NOTICE OF DECISION

Tri Mountain Industrial Park Site Plan Review

File No. PLZ-21-0094

Proposed Site Plan

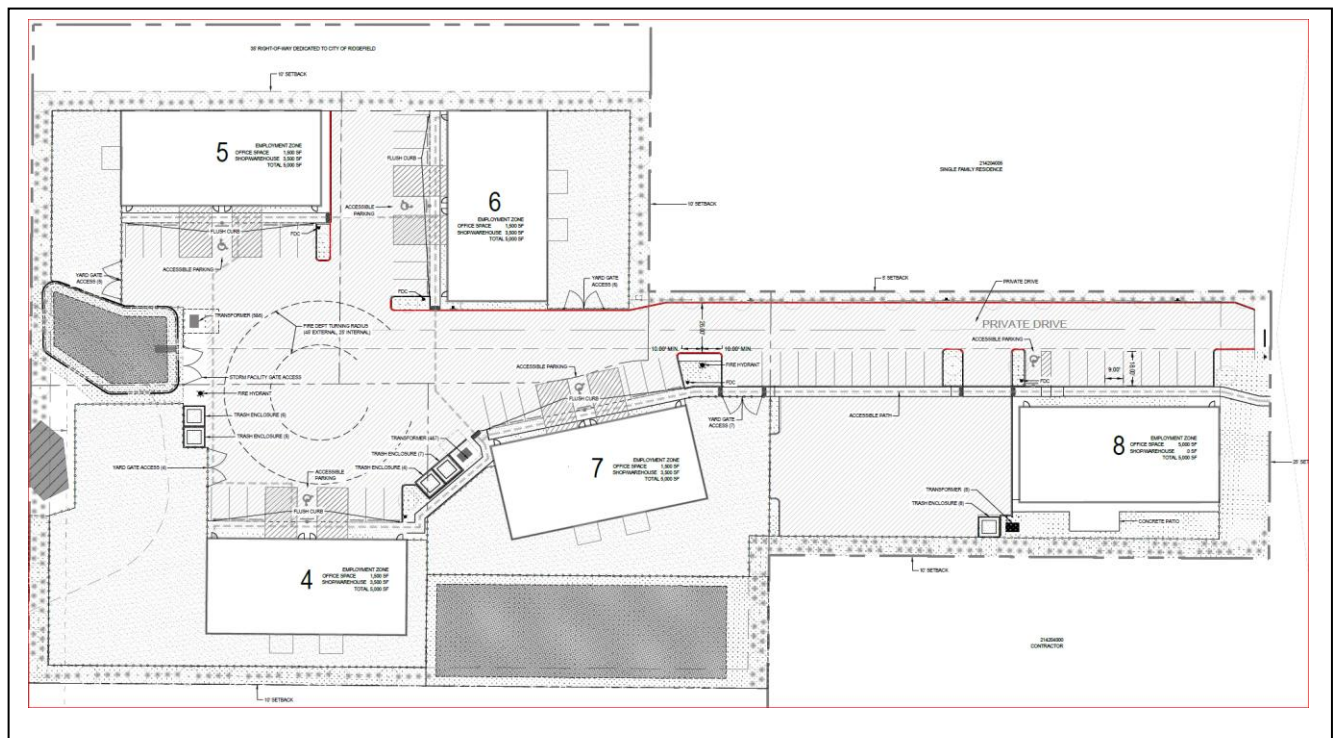
All buildings have one face fronts the private drive. The building on Lot 8 also faces NE 10th Ave. Buildings 4, 5, 6, and 7 have 10-foot landscape setbacks at the rear yards. Building 8 is setback 25 feet from NE 10th Ave. The building height of all buildings is 19 feet-1 inch to the top of the ridgeline from finished grade. Total impervious surface area is 73%. The proposal satisfies the dimensional standards in Table RDC 18.240.055-1.

The applicant proposes two trash enclosures for buildings 4 and 5 and for buildings 6 and 7, and two transformers around the perimeter of the fire turn-around at the end of the private drive. The trash enclosure and transformer for building 8 is south of the building between the building and landscaped setback. As a **condition of approval**, the applicant shall demonstrate that the trash enclosure and transformer south of building 8 is screened or landscaped to an 80% year-round opacity from public view along NE 10th Ave.

- 3) At time of building permit, building 8 shall demonstrate compliance with RDC 18.240.060.A.3, A 4, and A5., site and building design
- 4) Prior to occupancy, the applicant shall demonstrate that the trash enclosure and transformer south of building 8 is screened or landscaped to an 80% year-round opacity from public view along NE 10th Ave.
